**Replacement Requirement for Pressure Sensors for Refrigerant Circuit - Mixed Installation Not Permitted (70/24)**

Model Line: **Taycan (Y1A/Y1B/Y1C)**

Concerns: **Refrigerant circuit pressure sensors**

Installation position of pressure sensors

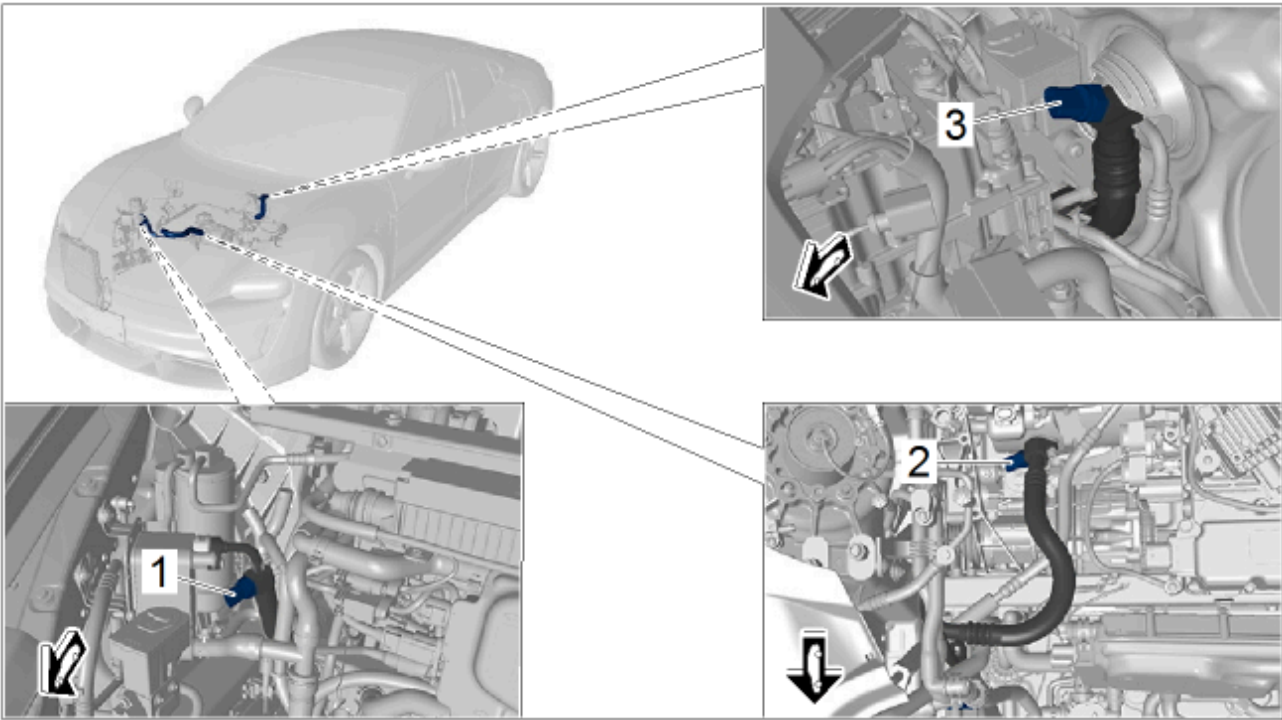
**Cause:** **Due to the discontinuation of an electronic component within the pressure sensor, the pressure sensors for the refrigerant circuit have been switched to a changed component status.**  
 The changed component status can be identified by a changed part number.  
 Pressure sensors that correspond to the changed component status are not compatible with the previous pressure sensors.  
 If there is replacement requirement for a pressure sensor, it must therefore be ensured that all pressure sensors in the refrigerant circuit correspond to the same component status (identical part number). If this is not the case, the respective other pressure sensor/s must also be replaced as a one-off. Mixed installation of pressure sensors with different component status (mixed installation) is not technically permissible and leads to faults in the refrigerant circuit and in the air conditioning.

Action: If there is replacement requirement for a pressure sensor, ensure that all three pressure sensors in the refrigerant circuit correspond to the changed component status with the part identification 4M0959603J.

If this is not the case, all **three** pressure sensors must be replaced.
